Project number: ERC0274

Primary frequency response rule changes (Mandatory primary frequency response) Consultation Paper

Figure 1: Regulation FCAS revenue drives batteries' profitability in Q2¹

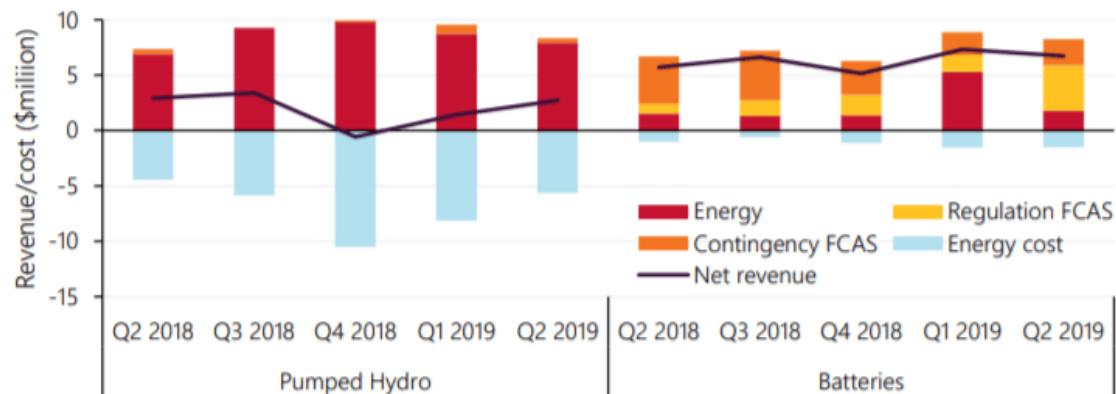
Providers of a primary regulating response should be remunerated for the costs of providing the service. Figure 1 below shows that there are costs in providing frequency control for pumped hydro. Providing primary frequency represents a cost in terms of wear and tear and efficiency but there is minimal financial benefit in providing the service. A reduction in primary frequency service providers in the NOFB increases the ‘workload’ on the remaining generators providing this service which in turn encourages these generators to stop providing the service. The opportunity costs associated with the provision of response and headroom under mandatory approach are likely to be substantial which will not likely be economically efficient and hence not consistent with the NEO.

Figure 2: Regional Frequencies and RoCoF during the event

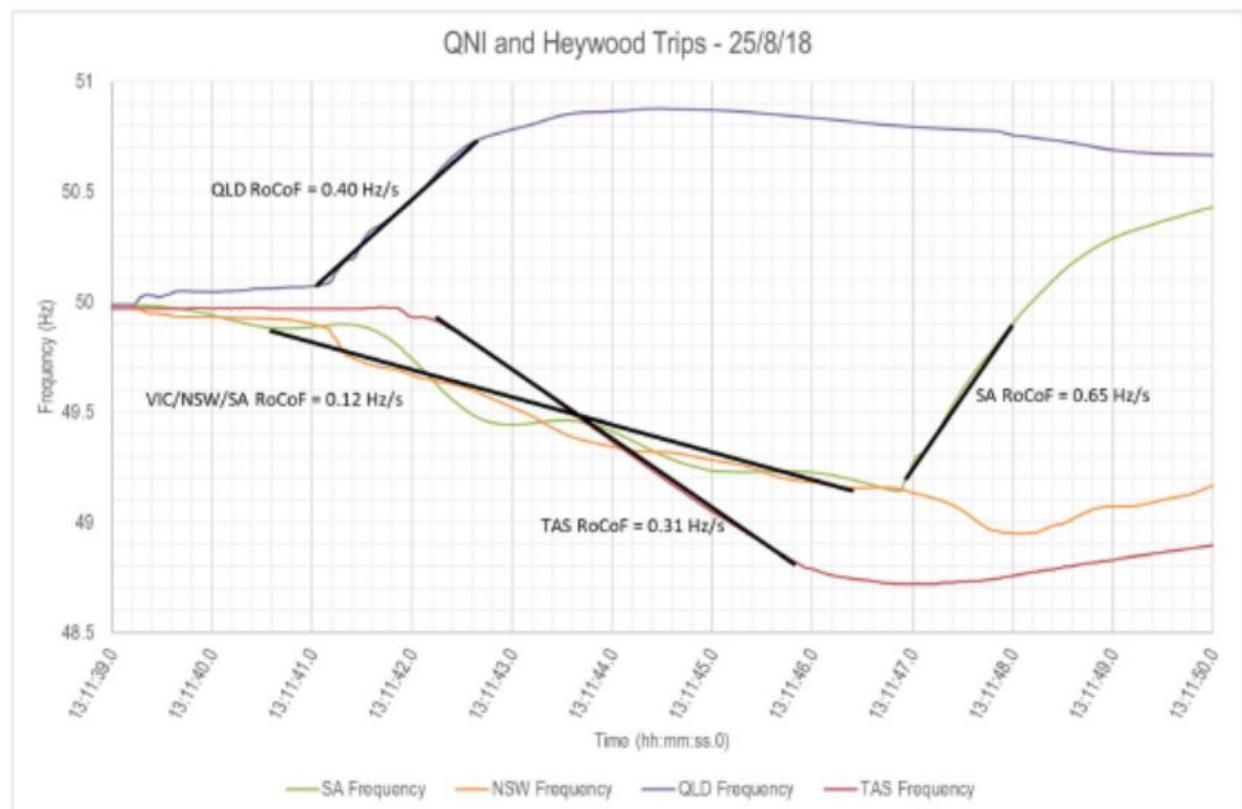
The concerning aspect of the rule change is that it appears to be driven by the Queensland and South Australia system separation on 25 August 2018:

- Primary frequency response of Vic-NSW island appears to have been sufficient as per FOS.
- Primary frequency response in QLD was the issue (along with SA) - although sufficient PFC was provided by QLD generators to reduce QLD frequency to near 50.6Hz immediately after frequency spiked to max level after the separation event.
- AEMO AGC continued to dispatch raise FCAS to QLD when QNI had separated (95MW) until 13:20 (as it was slow to adjust to new network topology post QNI separation).
- AEMO NEMDE contributed heavily to sustained high QLD frequency by continuing to over dispatch high targets in QLD (800MW+).
- This is the fundamental issue as dispatch compliance has been prioritised above compliance.
- The issue appears to be with the setup of NEMDE, not the lack of existing frequency response.

Figure 3: QLD and VIC/NSW Frequency

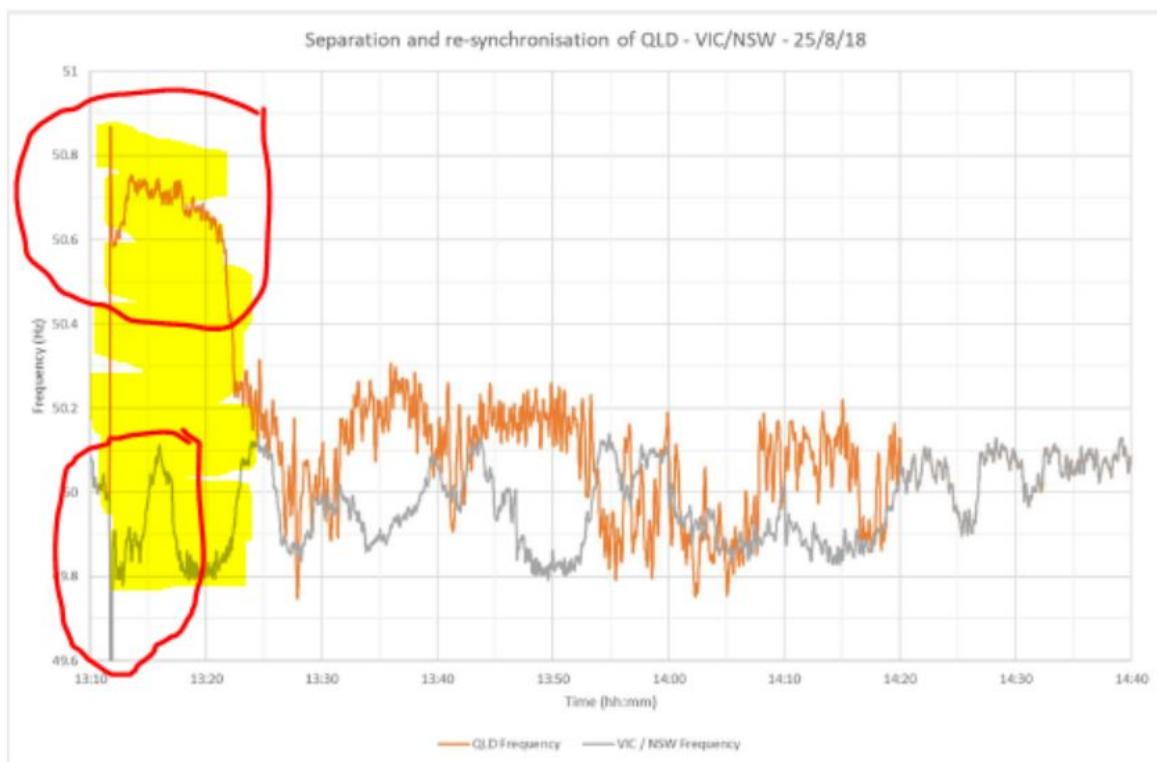
It is for this reason Snowy Hydro does not believe the mandatory proposal will solve the immediate concerns noted in the consultation paper. Minimum volumes of contingent FCAS is always enabled in each electrically islanded network that can be separated by an interconnector in combination with the global requirement (eg. contingent FCAS requirements for each RRN in addition to global requirement).

Figure 4: Frequency distribution within the normal frequency operating band in the NEM 2005 snapshot v. 2018 snapshot⁴

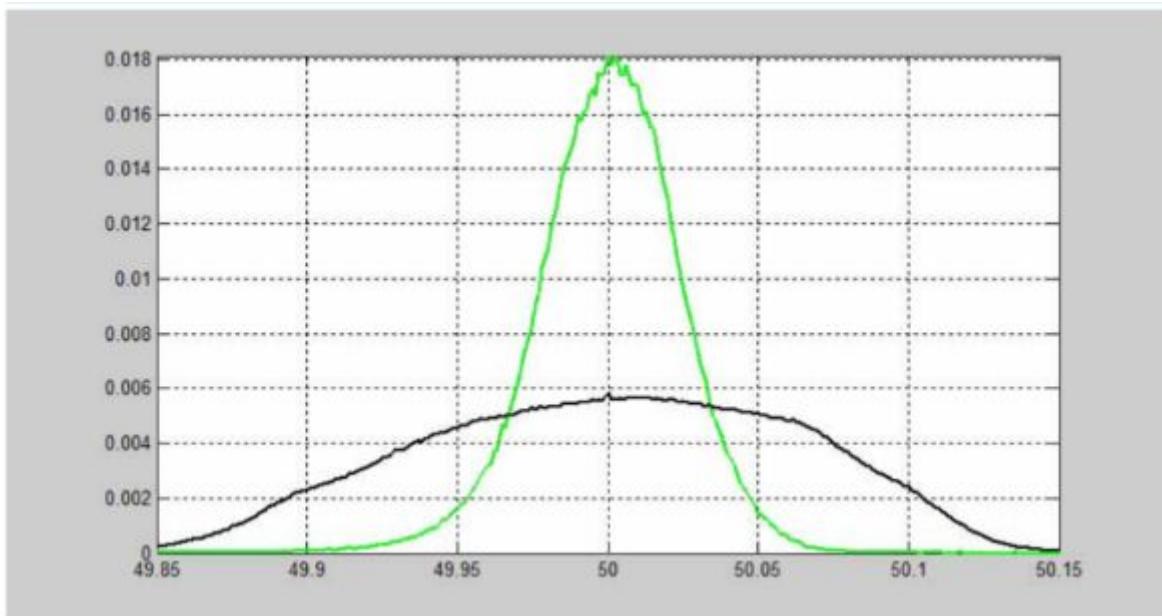
The consultation paper shows the frequency distribution within the normal frequency operating band in the NEM between 2005 and 2018, as shown below, highlights the problem with changing frequency. Snowy Hydro is concerned by this comparison as it is a redundant comparison undertaken by AEMO. In 2005 there was a large amount of headroom in NSW and Victoria synchronous generators whereas in 2018 there was minimal on the NSW and Victorian synchronous generators.
